MILITARY RELOCATION TO GUAM AND CNMI PROGRAMMATIC AGREEMENT (PA) MEMO #2

Project : P-103 Water Well Development-Design and	Date: February 15, 2018
Construction	Comment Period Closed:
SHPO Reference: RC# 2016-0122	March 26, 2018
Project Location: Andersen Air Force Base	Prepared By: NAVFAC Pacific

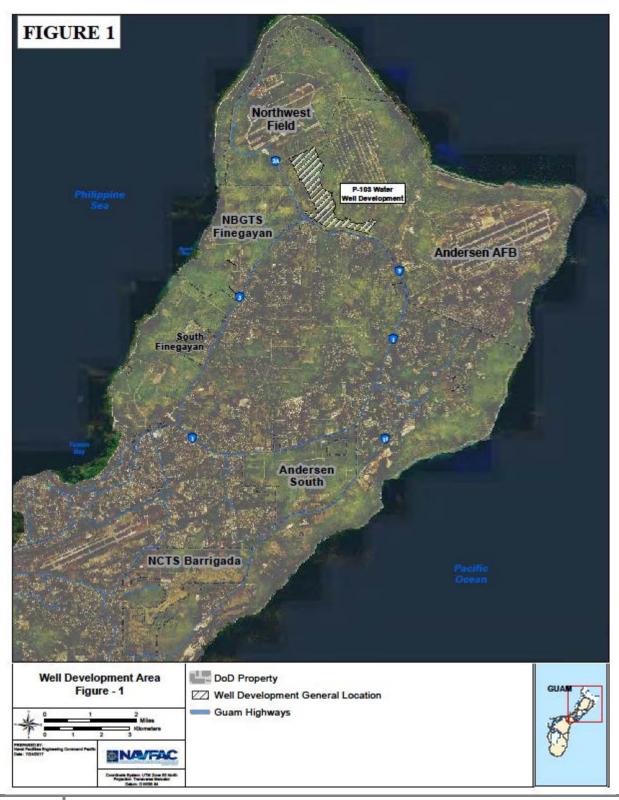
3. The sequential resurvey of the indirect portion of the Live Fire Training Range Complex (LFTRC) found two sites of some magnitude, where the LFTRC survey found no sites in the area. The findings of overlapping survey indicate to us that there are grave inadequacies in the surveys conducted in these areas. Also, buried features and burials have been found on the plateau since the presentation of Record of Decision. It should also be noted that Church et al. did not survey the 140 acre parcel as presented in this PA Memo, rather Church et al. only surveyed the perimeter for the fence line. This is a misrepresentation of the work conducted has been pointed out to NAVFAC PAC before and should not be repeated. Such misrepresentations reflect on the integrity of everything that NAVFAC PAC presents to our office. Therefore, due to the changes in the AP, new sites found in areas previously surveyed for the build-up, the inconsistencies and inadequacies of the previous surveys in this area, the subsurface finds and burials located on the plateau and the 90 degree angle of (GHPI) Number 66-08-2894, one of the Caiguat sites we require a resurvey for this revised project with systematic subsurface testing throughout the area.

The Well Development area has been sufficiently investigated for archaeological resources as part of DON's section 110 responsibility under NHPA in 2004 and 2014. NRHP eligibility assessments were completed as per 36 CFR 800.4(c)(1 and 2). The Church et al. polygon referenced in your comment was included in error, but this has since been resolved with our Geographic Information Systems (GIS) Specialist. The Church et al. survey referenced in this PA Memo still applies. The DON continues to work with the SHPO's office to reconcile the numerous geodatabases being employed by multiple users. The Guam Synthesis task order currently being completed focuses on refining the data and providing a geodatabase.
